**BEFORE INDEPENDENT HEARING COMMISSIONERS
APPOINTED BY THE HAMILTON CITY COUNCIL**

IN THE MATTER of an application for subdivision and land use
consent for the Amberfield development
pursuant to the Act.

APPLICANT Weston Lea Limited

**STATEMENT IN ANSWER TO QUESTIONS OF THE HEARING PANEL
RAISED IN DIRECTION NO. 9**

Lux Spill Distance Analysis

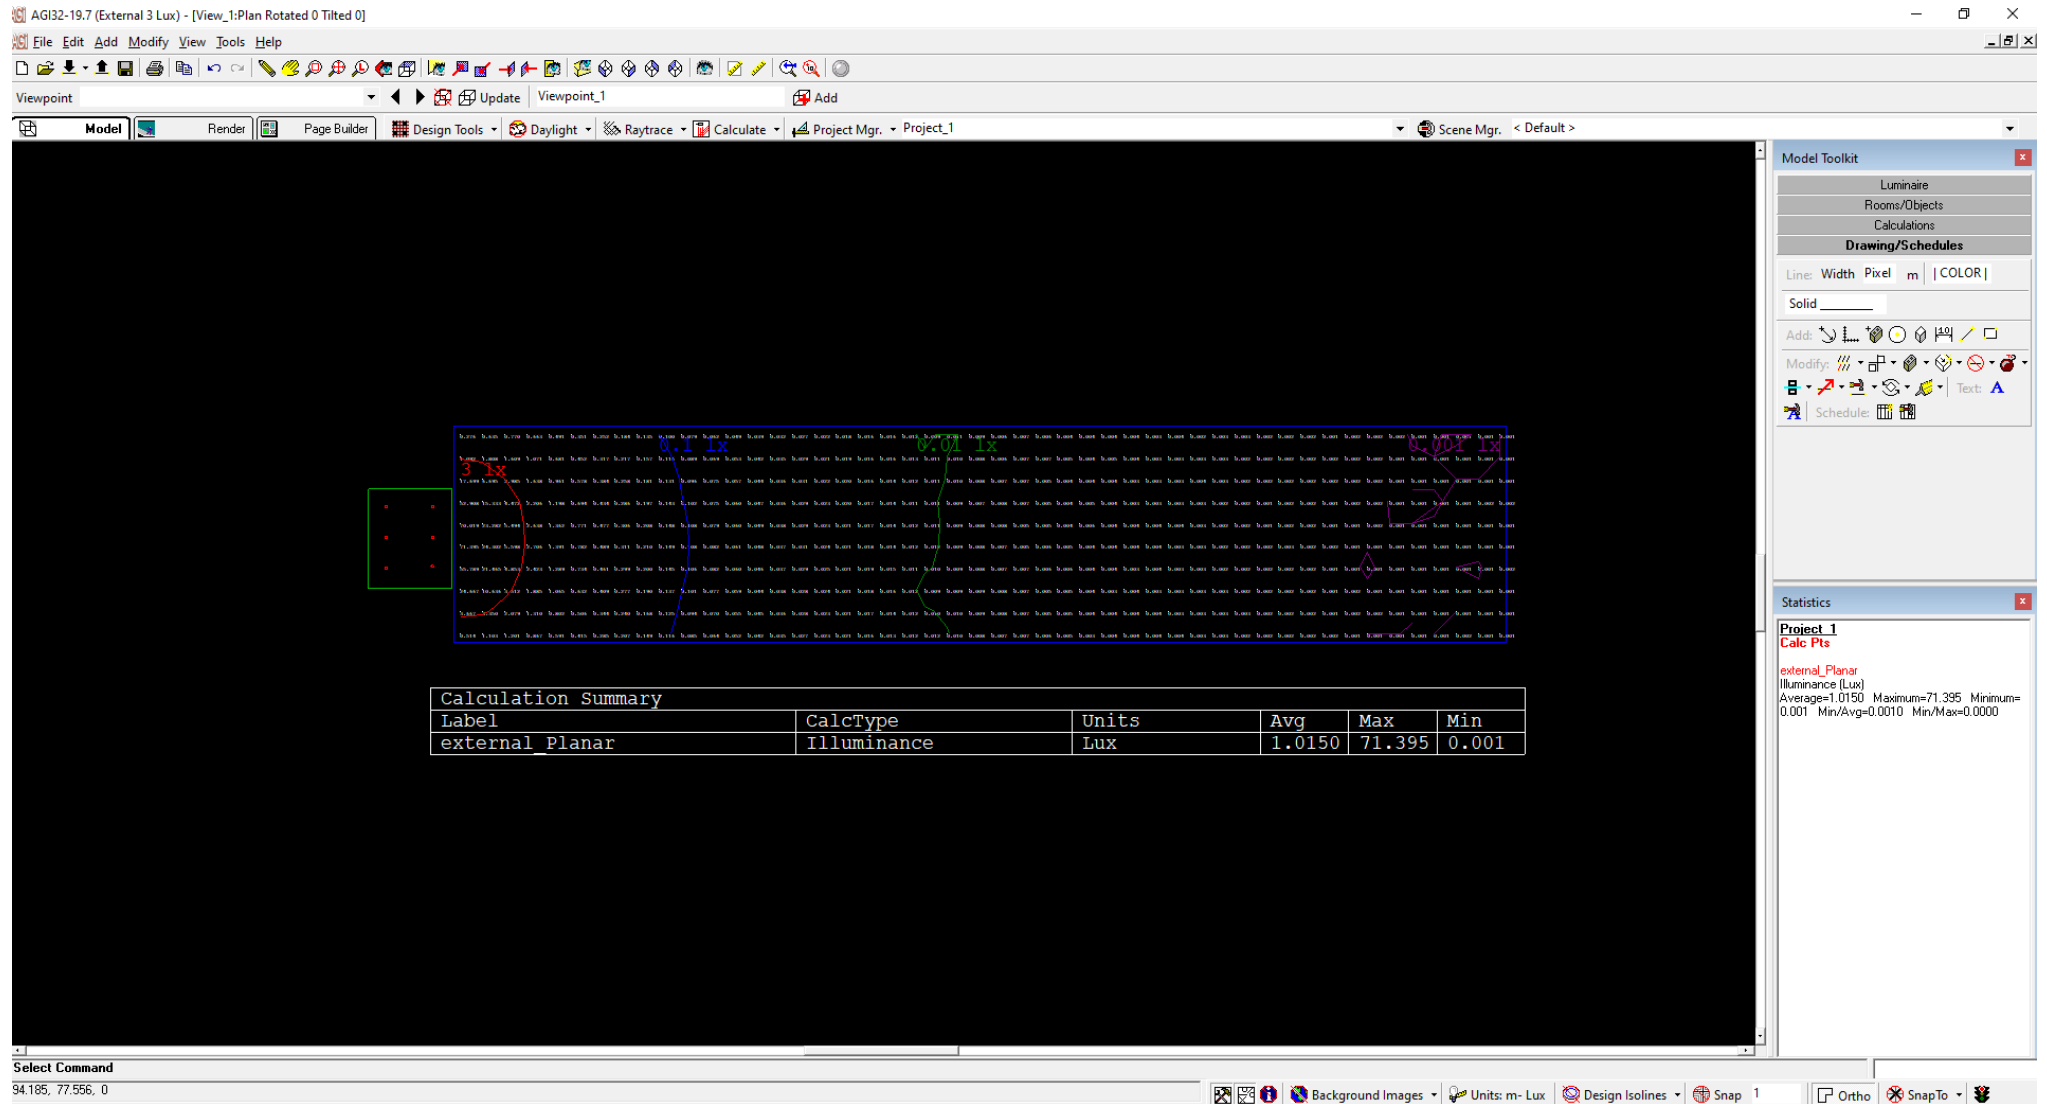
8. Light spill from internal residential lighting sources can also add to ambient light, although in my experience these lighting sources cannot be controlled in any consistent manner. In any case, I consider that light spill from houses will attenuate to low levels very quickly. In order to better illustrate how quickly measurable light attenuates I have produced a Lux Spill Distance Analysis Report. I attach my analysis as **annexure A**.

9. My analysis, under annexure A, shows that if there is light spill measuring 3 lux at the boundary then at 7.4m from the boundary it would measure 0.1 lux, at 17.9m from the boundary it would measure 0.01 lux, and at 37.8m from the boundary it would measure 0.001 lux. Light levels at 0.001 lux are regarded as darkness.

3 lux at the boundary. I note it was quite difficult to create a theoretical 3 lux spill at the boundary. In order to show 3 lux spill at the boundary, my analysis assumed a window the full width of a room 3.3m metres away from the boundary. I would not anticipate that 3 lux spill at the boundary would be normally reached in a standard residential setting.

Annexure B – Light Spill Diagrams

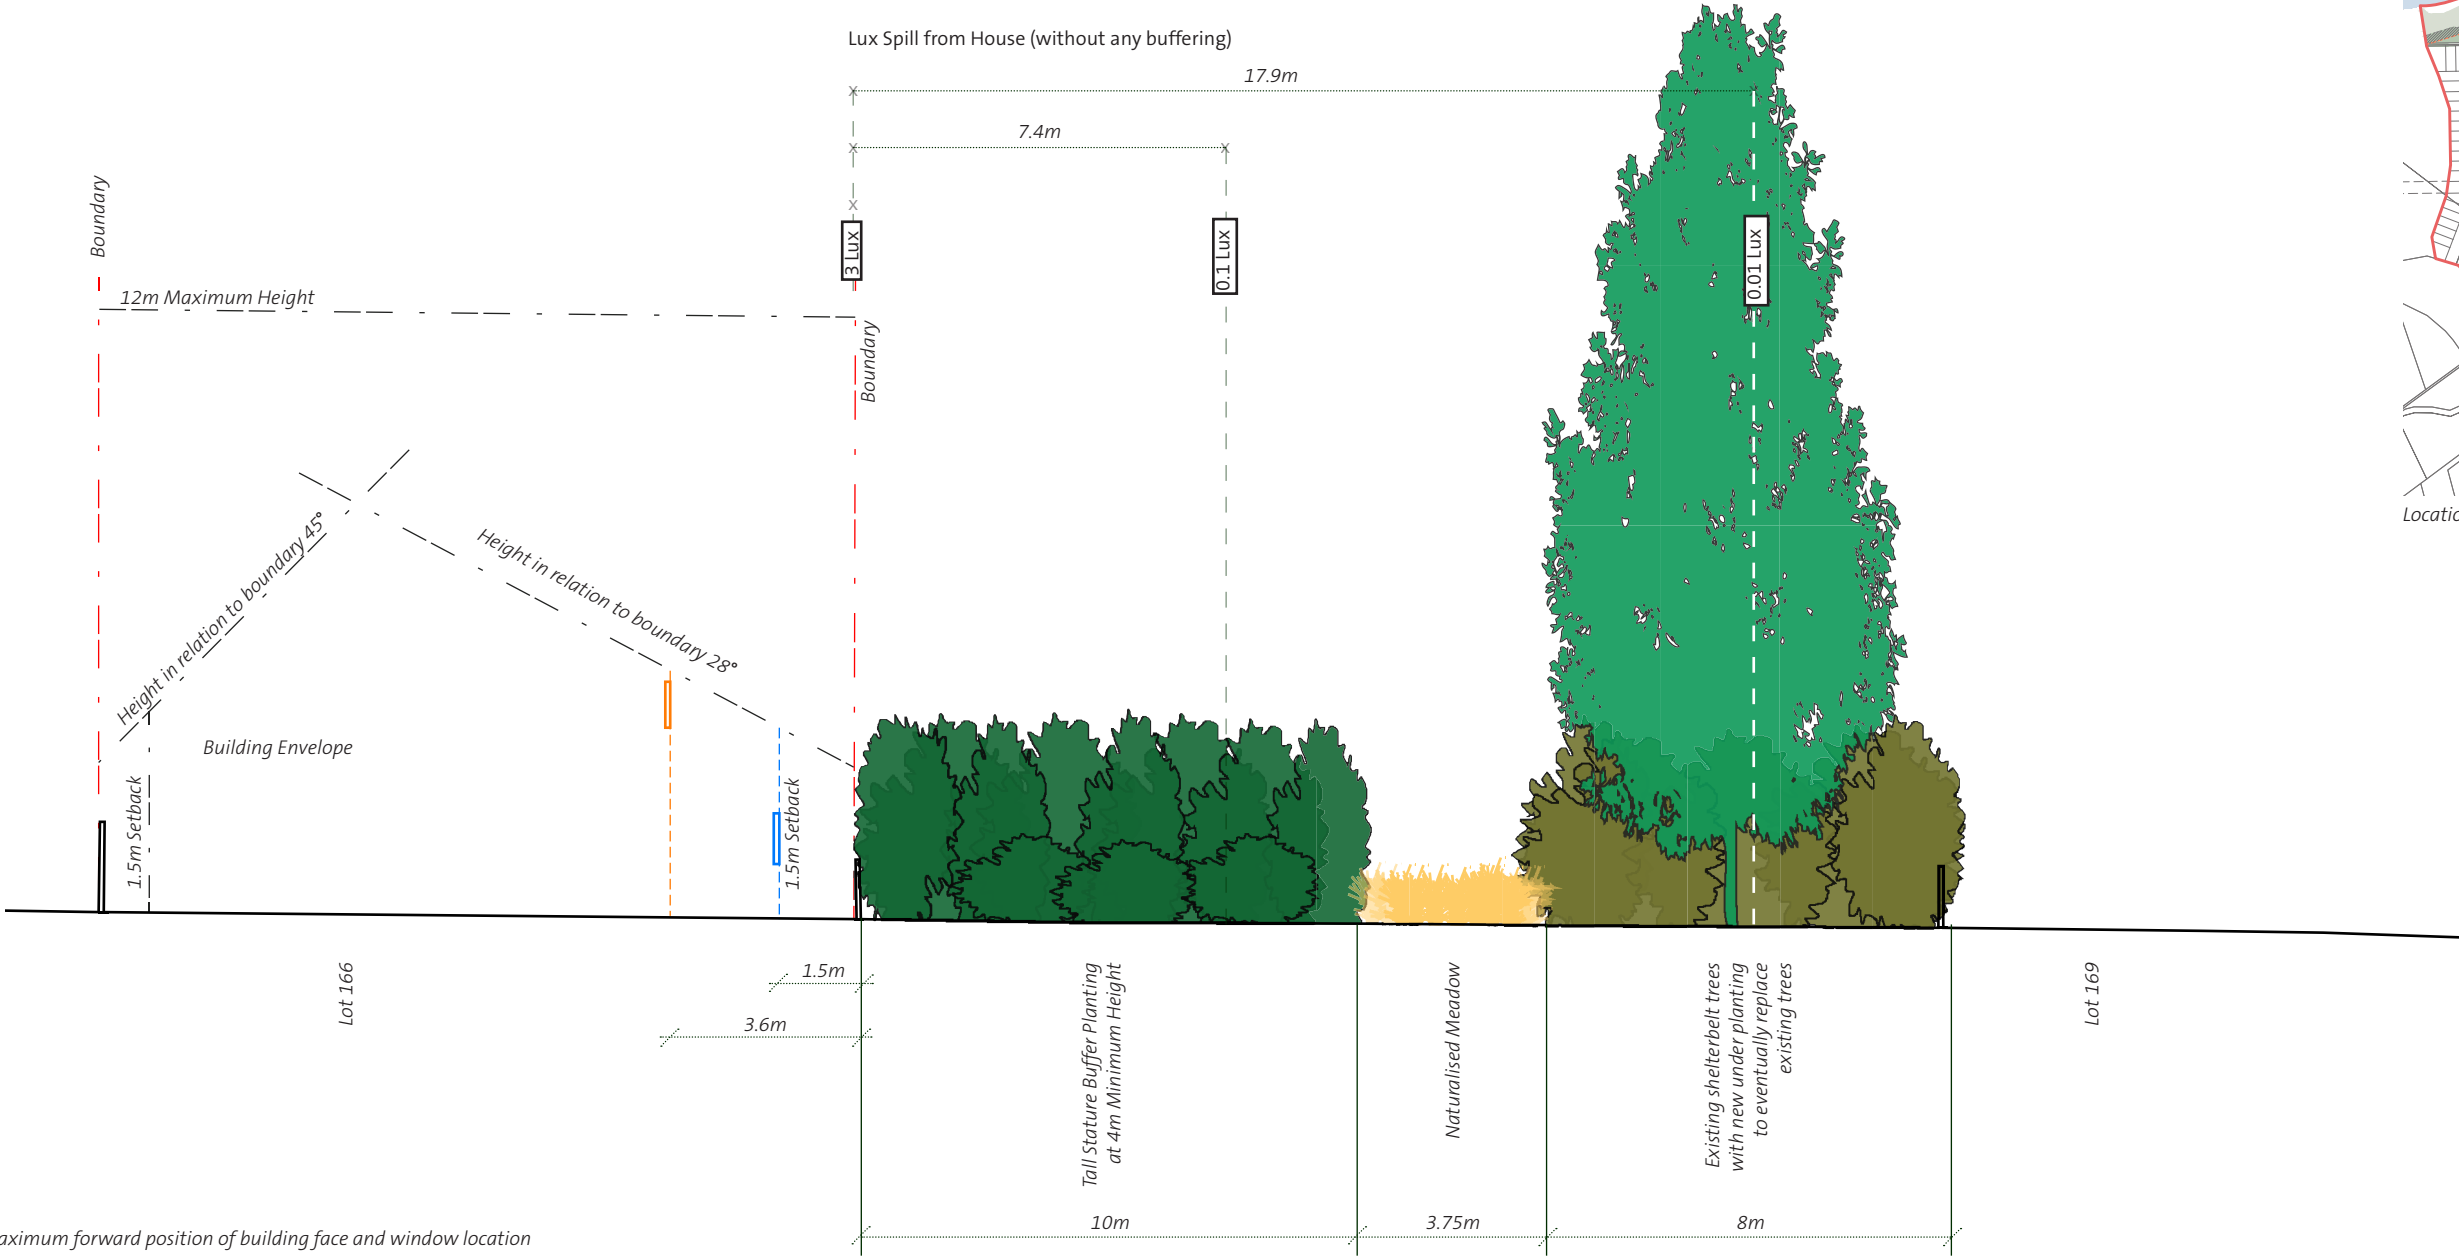
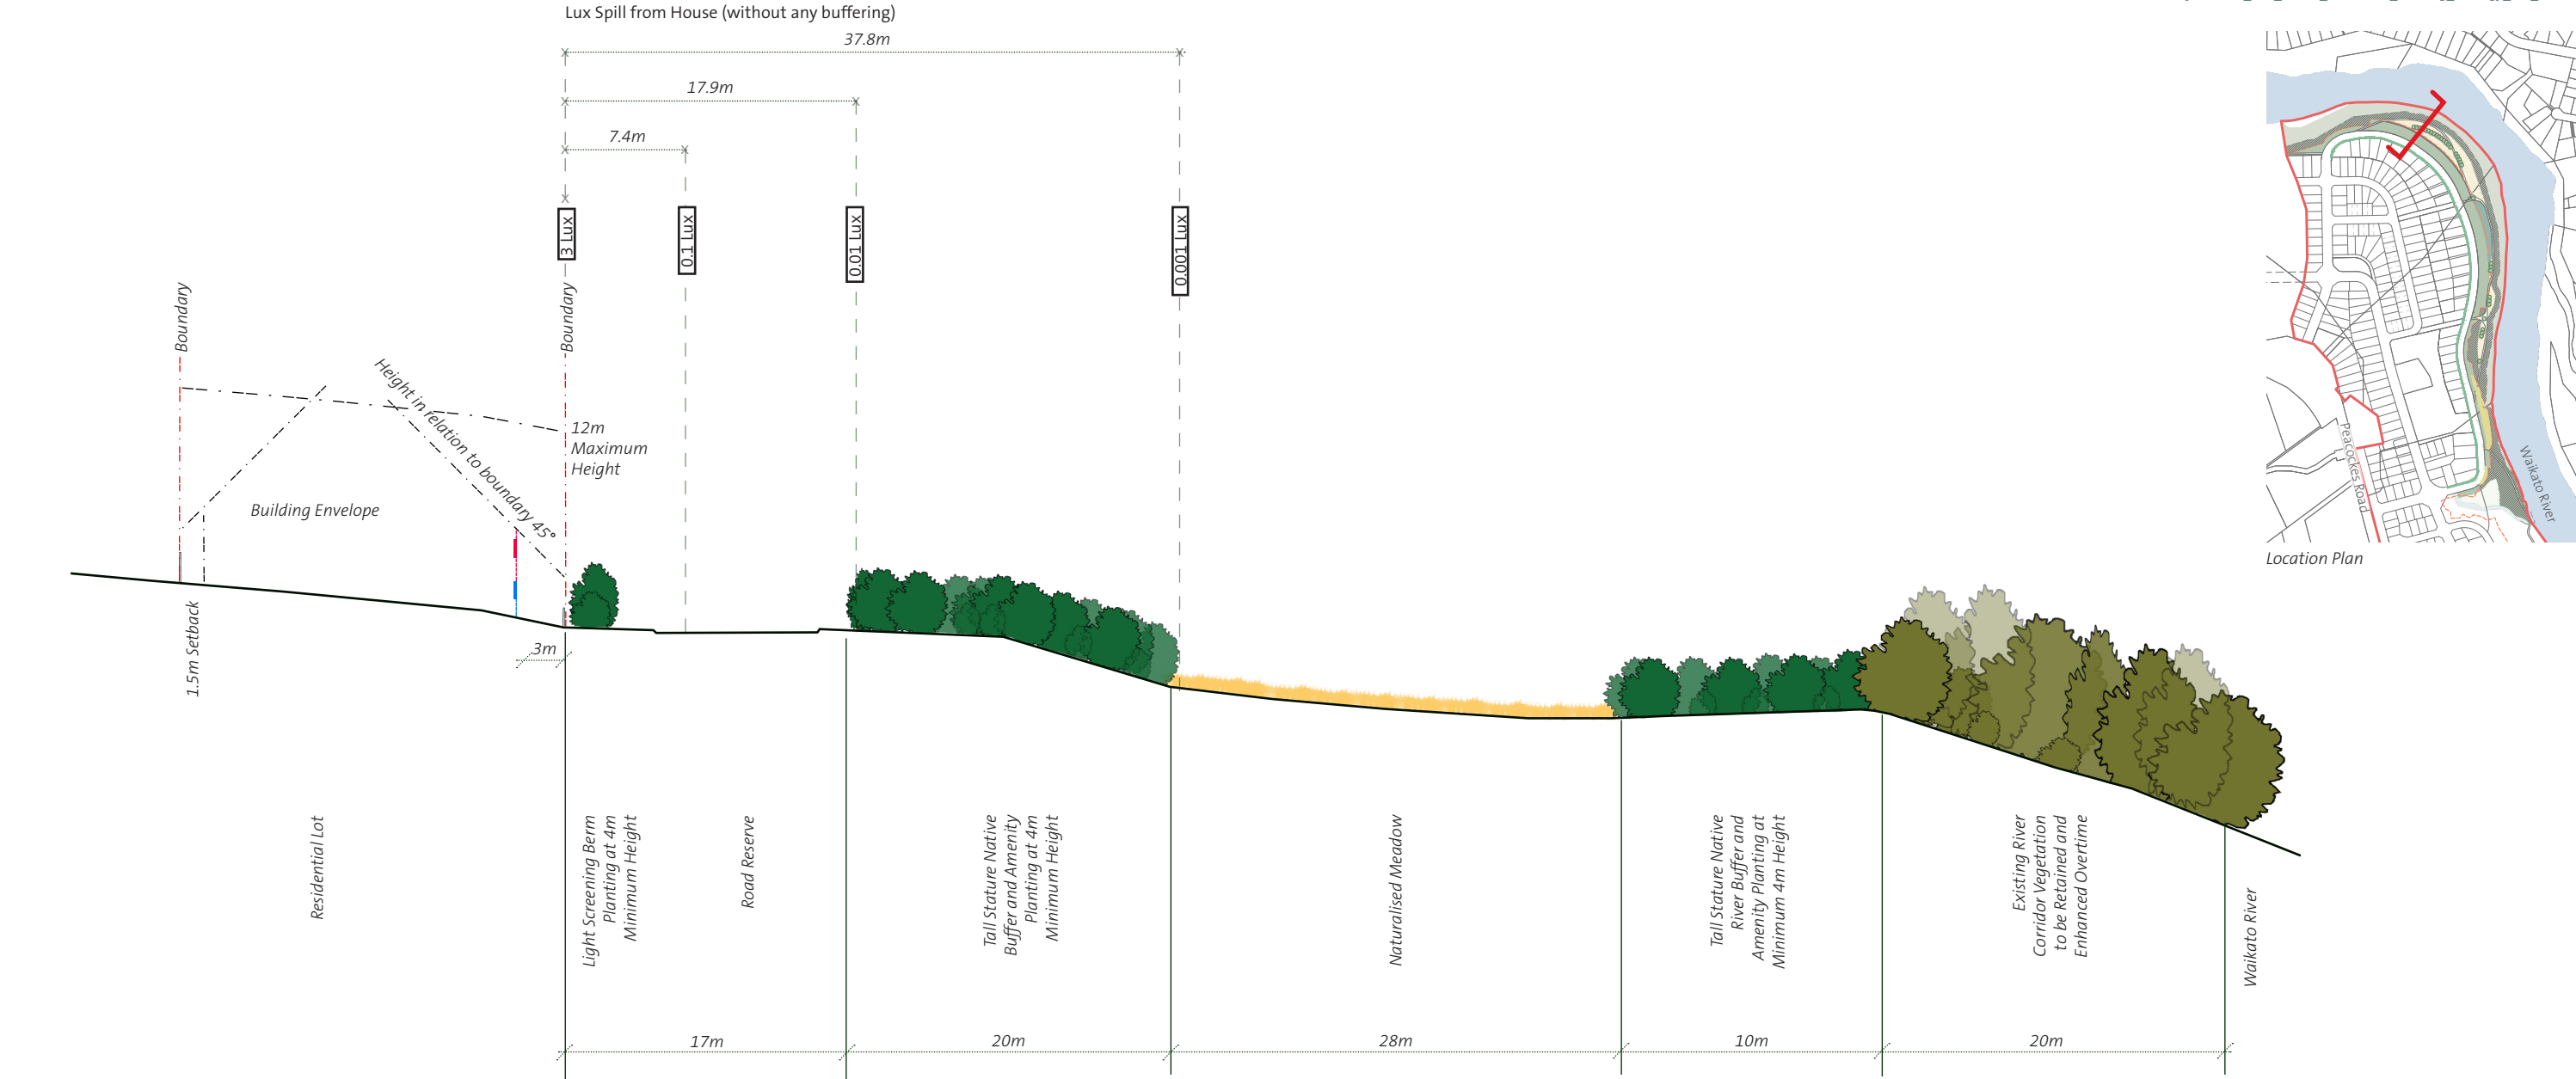
11. Boffa Miskell have also translated my analysis onto the cross section of bat sensitive areas, in particular, the North-Eastern Terrace and East-West Shelterbelt. These diagrams are attached as **annexure B**.

12. To confirm, these diagrams only show the light spill from a house. If the proposed streetlights were to be added to the streetscape, their light spill would be added to the lux spill from the houses (i.e. a cumulative effect). However, as noted above, the proposed lighting design calculations for the perimeter roads, such as the one depicted on the North-Eastern Terrace Cross section, shows the light spill being very well controlled. Light spill reduces to zero lux at 12.2 meters from the light source which will be within the vegetated buffer (adjacent to the road reserve).

13. I also note that these diagrams illustrate the anticipated light spill without the effect of the vegetated buffer that will effectively block light.

18. As shown the light diagram attached as Annexure B the light from a dwelling can be attenuated to 0.1 lux at 7.4 m from the source without buffering.
